**BEFORE THE PUBLIC SERVICE COMMISSION  
OF THE STATE OF NORTH DAKOTA**

Denbury Green Pipeline – North Dakota, LLC  
12-inch Cedar Hills Pipeline Project  
Slope and Bowman Counties  
Siting Application

Case No. PU-19-294

**APPLICATION FOR AMENDMENT OF  
CERTIFICATE OF CORRIDOR COMPATIBILITY**

Figure 2. Route Adjustment No. 1 location map.

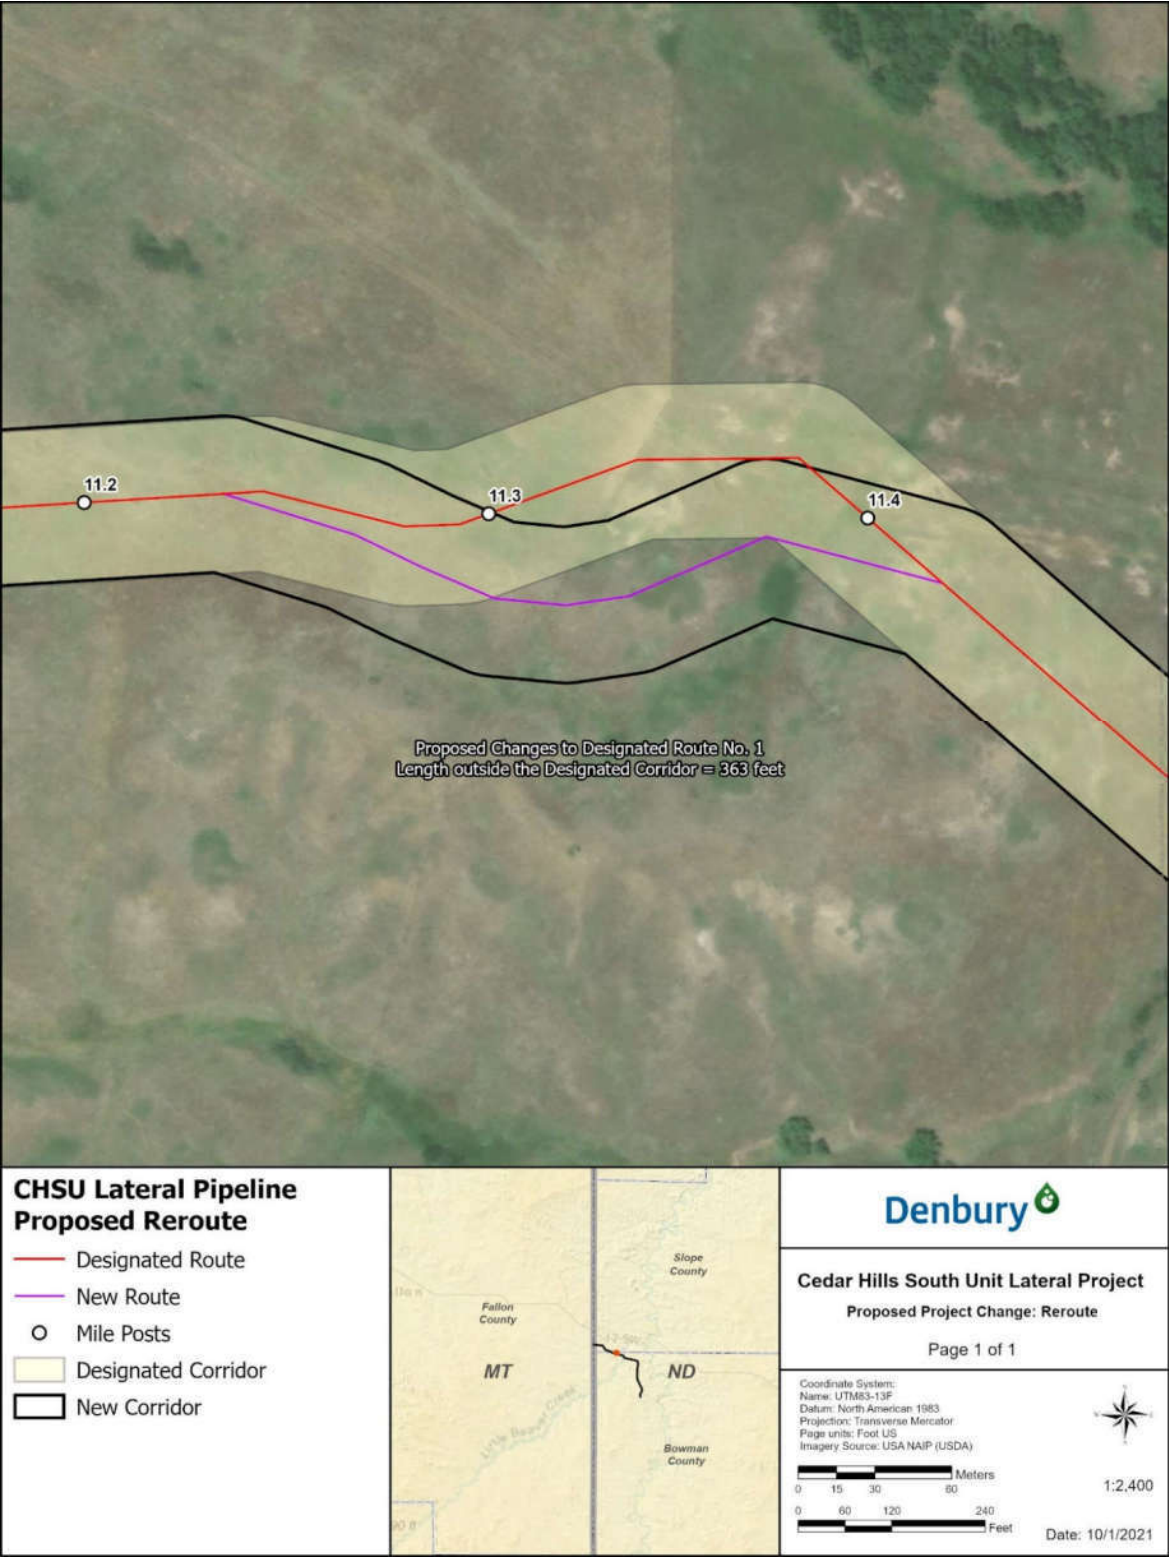
- Route Adjustment No. 1 – the route adjustment is completely within the one-mile-wide project study area for the desktop analysis and approximately 363 feet of the reroute lies outside of the Designated Corridor (Figure 2). No transmission facility corridor and route exclusion and avoidance areas were identified during the desktop analysis and field surveys for the proposed pipeline route and aerial photographic interpretation of the route adjustment indicates that a pedestrian survey of the reroute is not warranted.
- Route Adjustment No. 2 – required for constructibility concerns; the route adjustment is completely within the one-mile-wide project study area for the desktop analysis and, while the rerouted pipeline itself lies within the Designated Corridor, approximately 2,689 feet of the associated temporary construction easement lies outside of the Designated

Figure 3. Route Adjustment No. 2 location map.

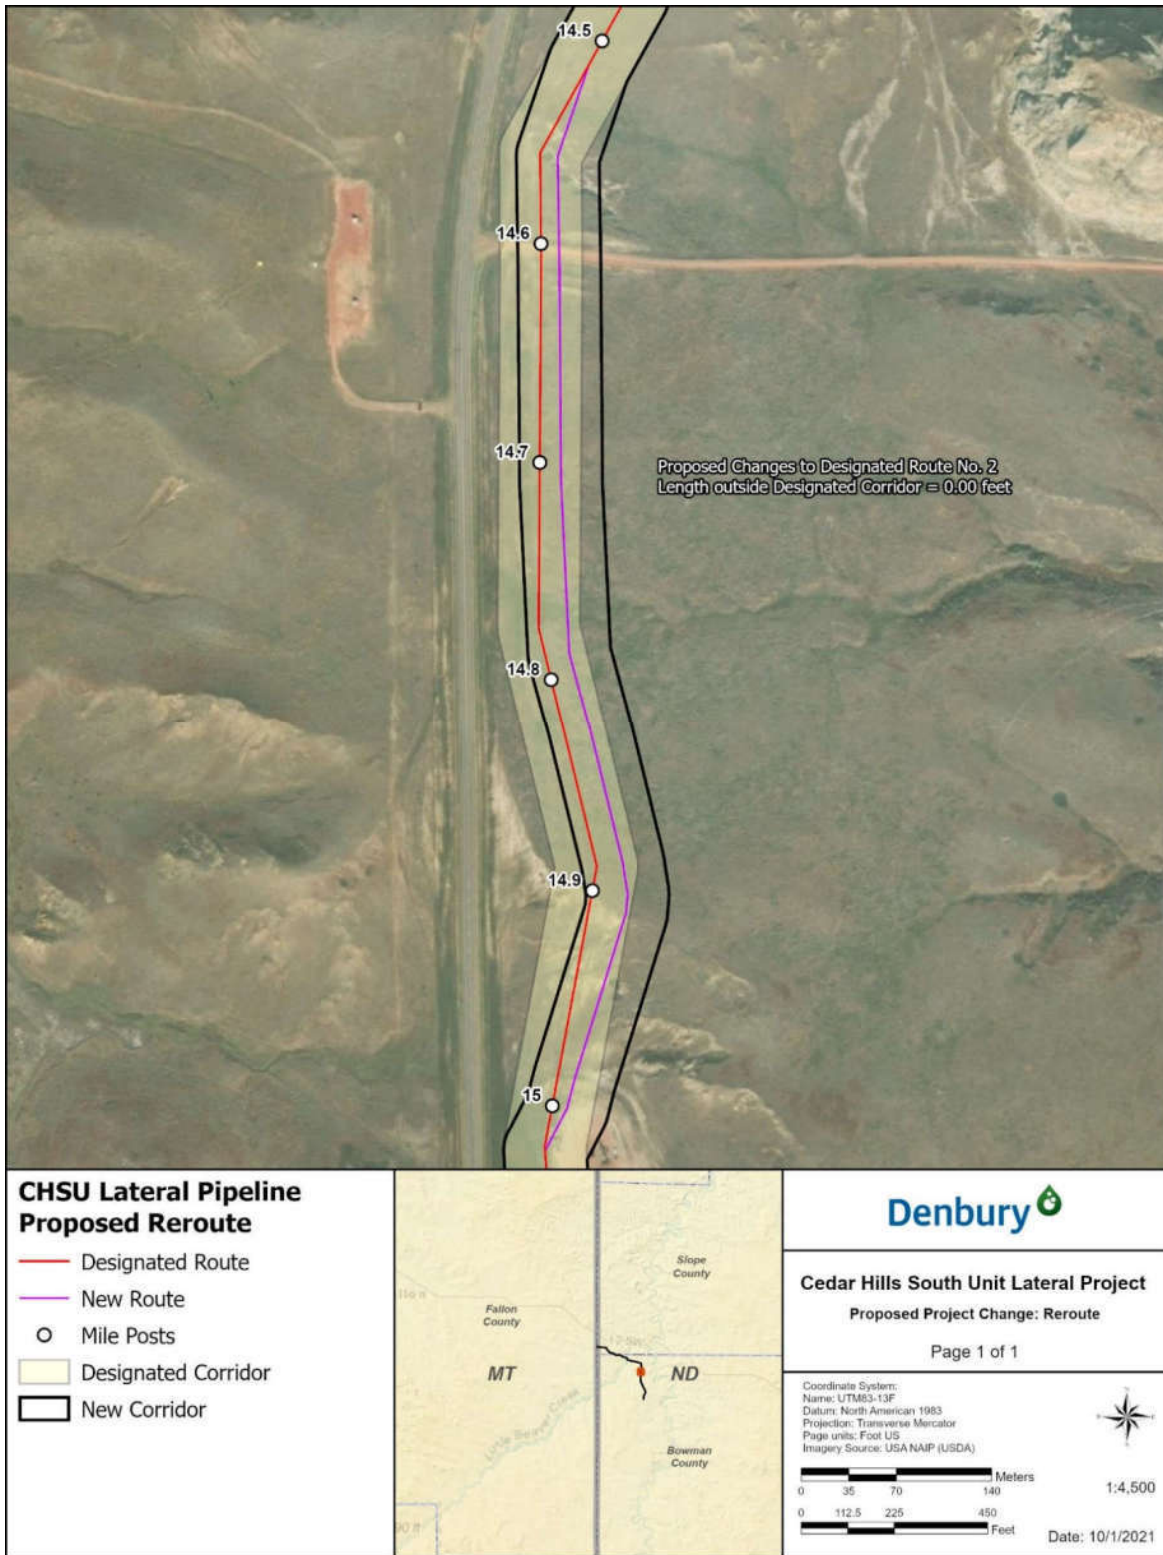
Corridor which will have to be relocate as shown in Figure 4. No transmission facility corridor and route exclusion and avoidance areas were identified during the desktop analysis and field surveys for the proposed pipeline route and aerial photographic interpretation of the route adjustment indicates that a pedestrian survey of the reroute is not warranted.

Figure 4. Proposed Corridor Additions 1, 2, 3, and 4 location map.

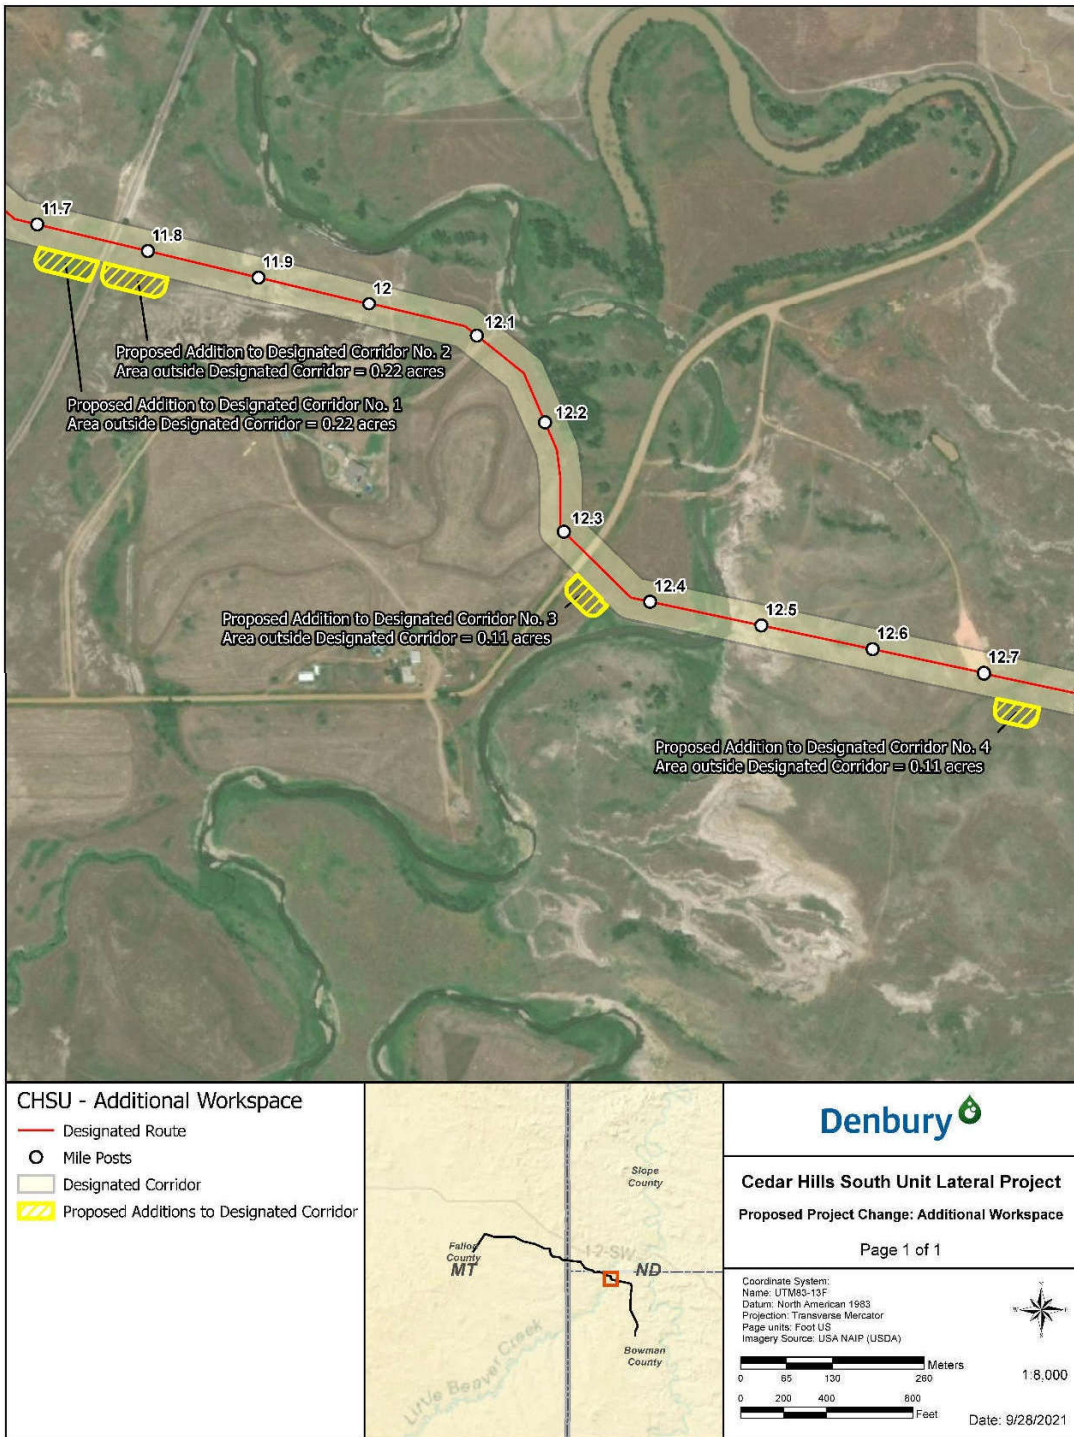
- Proposed Corridor Addition No. 1 – this proposed addition is for expansion of a temporary workspace area from approximately 100 x 100 feet to 100 x 200 feet, with an area that measures approximately 50 x 200 feet (0.22-acre) outside of the Designated Corridor (Figure 3). No transmission facility corridor and route exclusion and avoidance areas were identified during the desktop analysis and field surveys for the proposed pipeline route and aerial photographic interpretation of this proposed corridor addition indicates that a pedestrian survey of the area is not warranted.

- Proposed Corridor Addition No. 2 – this proposed addition is for expansion of a temporary workspace area from approximately 100 x 100 feet to 100 x 200 feet, with an area that measures approximately 50 x 200 feet (0.22-acre) outside of the Designated Corridor (Figure 3). No transmission facility corridor and route exclusion and avoidance areas were identified during the desktop analysis and field surveys for the proposed pipeline route and aerial photographic interpretation of this proposed corridor addition indicates that a pedestrian survey of the area is not warranted.

- Proposed Corridor Addition No. 3– this proposed addition is for a temporary workspace area that measures approximately 100 x 100 feet, with an area that measures approximately 50 x 100 feet (0.11-acre) outside of the Designated Corridor (Figure 3). No transmission facility corridor and route exclusion and avoidance areas were identified during the desktop analysis and field surveys for the proposed pipeline route and aerial photographic interpretation of this proposed corridor addition indicates that a pedestrian survey of the area is not warranted.

- Proposed Corridor Addition No. 4– this proposed addition is for a temporary workspace area that measures approximately 100 x 100 feet, with an area that measures approximately 50 x 100 feet (0.11-acre) outside of the Designated Corridor (Figure 3). No transmission facility corridor and route exclusion and avoidance areas were identified during the desktop analysis and field surveys for the proposed pipeline route and aerial photographic interpretation of this proposed corridor addition indicates that a pedestrian survey of the area is not warranted.

Figure 5. Proposed Corridor Addition No. 5 location map.

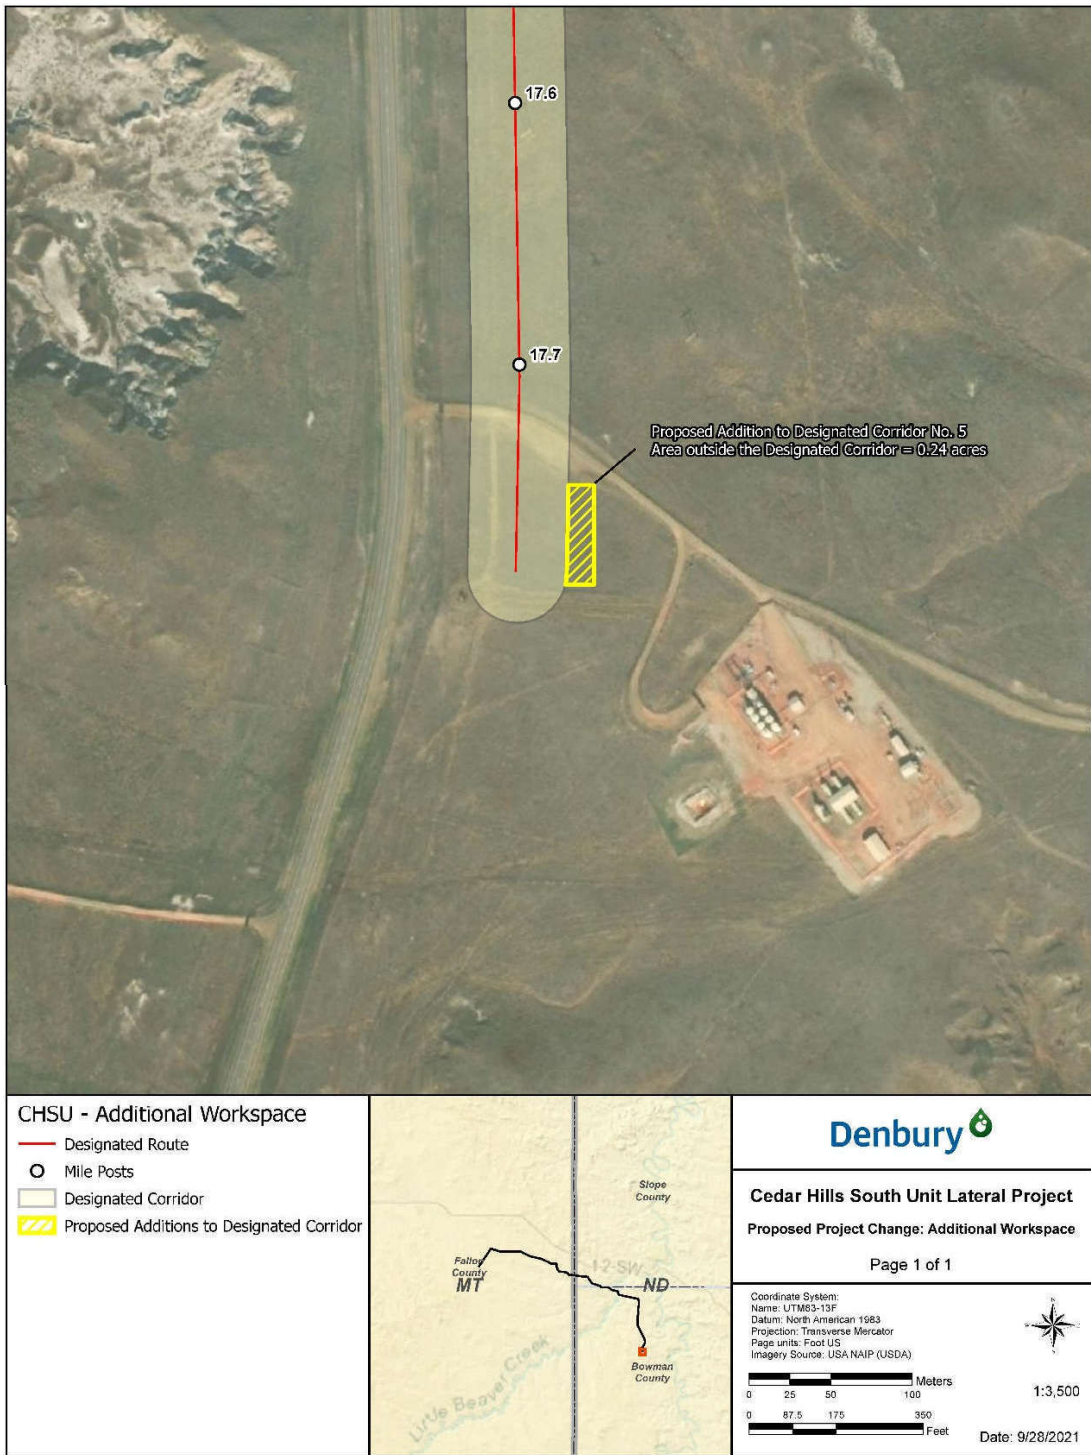
- Proposed Corridor Addition No. 5 – this proposed addition is for a portion of the Miller Station that measures approximately 52 feet by 200 feet (0.24 acre) that was not included in the previous field survey and Designated Corridor (Figure 3). No transmission facility corridor and route exclusion and avoidance areas were identified during the desktop analysis and field surveys for the proposed pipeline route and aerial photographic interpretation of this proposed corridor addition indicates that a pedestrian survey of the area is not warranted.

**Figure 1. Map with paleontological resource analysis areas for Reroute 1 and ATWs 1 through 4.**

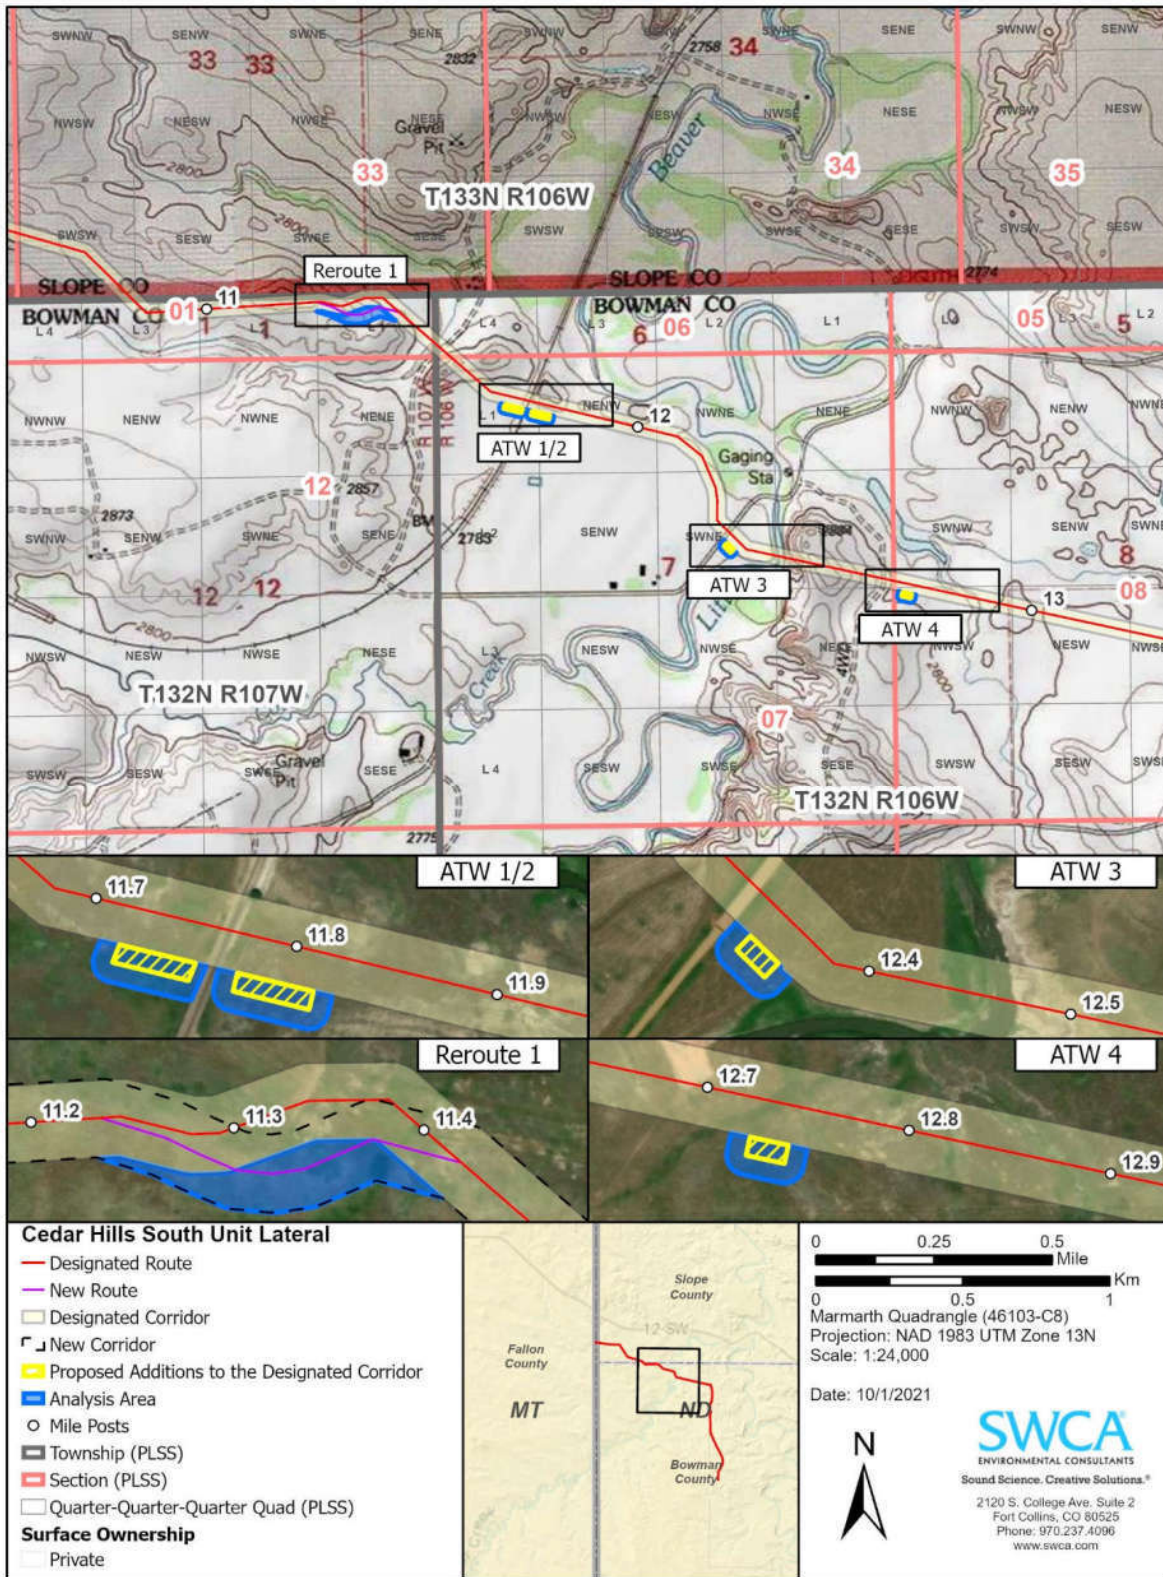
- Reroute 1 (# CHSU-CL-003), from milepost (MP) 11.2 through MP 11.4, is in a portion of the project that was previously cleared for paleontological resources through a review of aerial imagery due to the lack of bedrock exposures. The route adjustment to the south is completely within the property of Hadley Brothers LLP and the length of segment is 0.18 miles. Terrian, and the potential for bedrock exposures of mapped Fox Hills Formation, is the same as observed in the previously analyzed area along this portion of the pipeline. The area is mostly vegetated, sloping, with some cobble-armored slopes and ridges near MP 11.3, possibly representative of unmapped Quaternary or Tertiary gravels. No pedestrian survey was conducted. Exposed paleontological resources are not expected within the route adjustment.

- ATW 1 and ATW 2, near MP 11.7 and MP 11.8, respectfully, are in a portion of the project that was previously cleared for paleontological resources through a review of aerial imagery due to lack of exposures of the mapped Pierre Shale Formation. The area is mostly vegetated with minor weathered areas (or blow outs) within the ATW 2 analysis area. Exposed paleontological resources are not expected within the ATWs.

- ATW 3, northwest of MP 12.4, is in a portion of the project that was previously cleared for paleontological resources through an aerial image review due to lack of bedrock exposures. In addition, while conducting initial pedestrian surveys nearby, a paleontologist walked through the area to access the next survey area (i.e., bedrock exposure). The area is vegetated with no exposures of the mapped Fox Hills Formation. Exposed paleontological resources are not expected within the ATW.

- ATW 4, southeast of MP 12.7, is in a portion of the project that was previously cleared for paleontological resources through a visual review while conducting nearby pedestrian surveys due to a lack of bedrock exposures. The area is vegetated with no exposures of the mapped Hell Creek Formation. Exposed paleontological resources are not expected within the ATW.
